CONVAIR

COMMERCIAL CHANGE PROPOSAL

SPEC NO.: ZD- 22-321

CUSTOMER: AVENSA

Page 7a, C. G. DESIGN LIMITS:

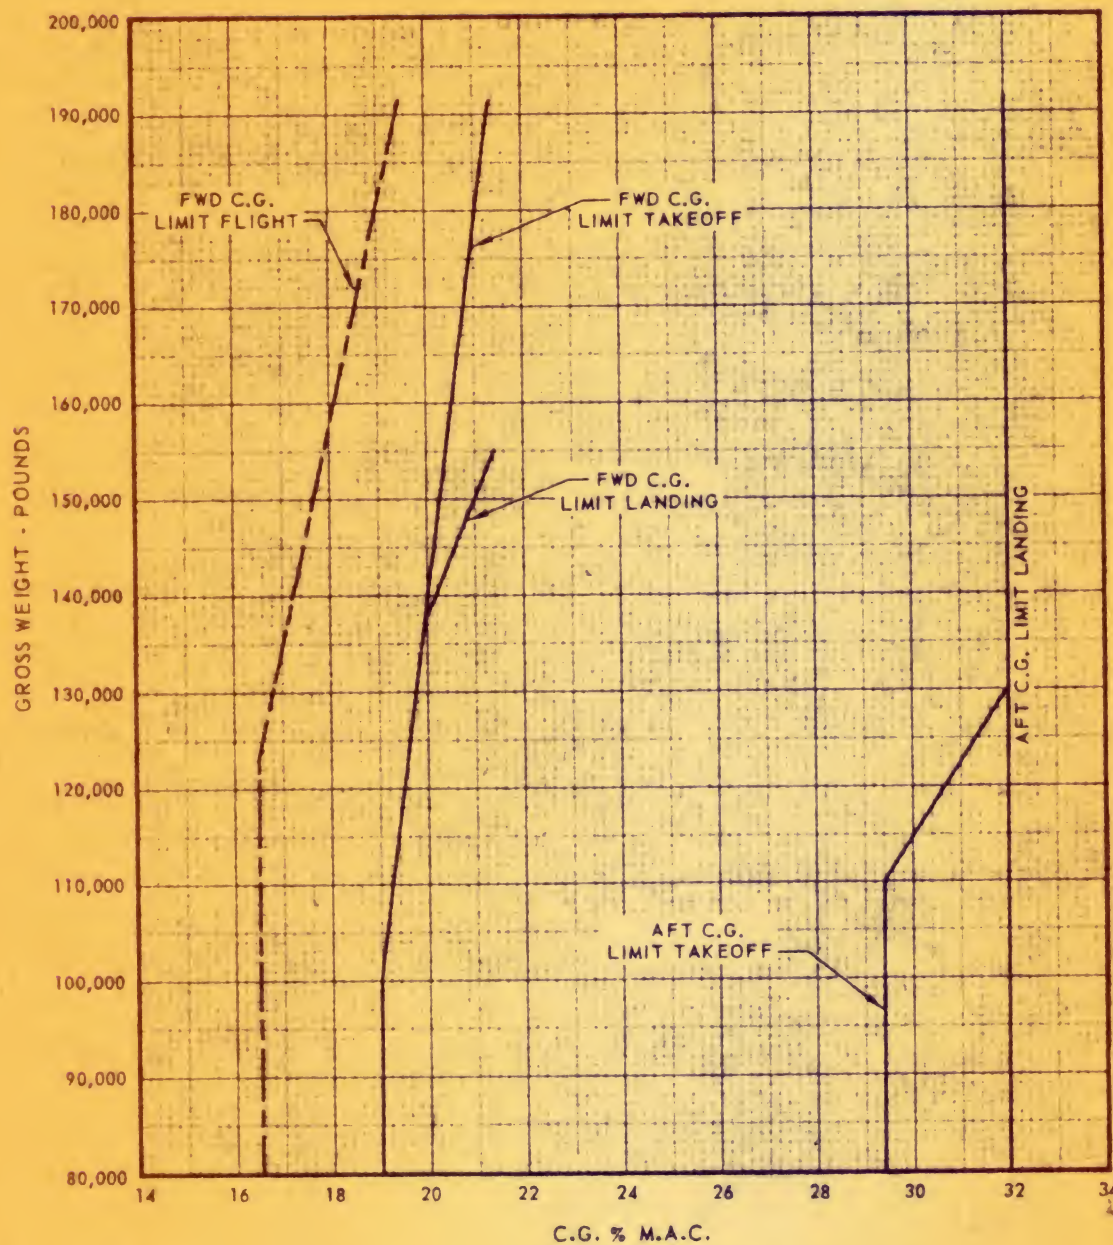
Replace above illustration in the specification with Enclosure (A) which adds new aft C. G. Limit takeoff and landing.
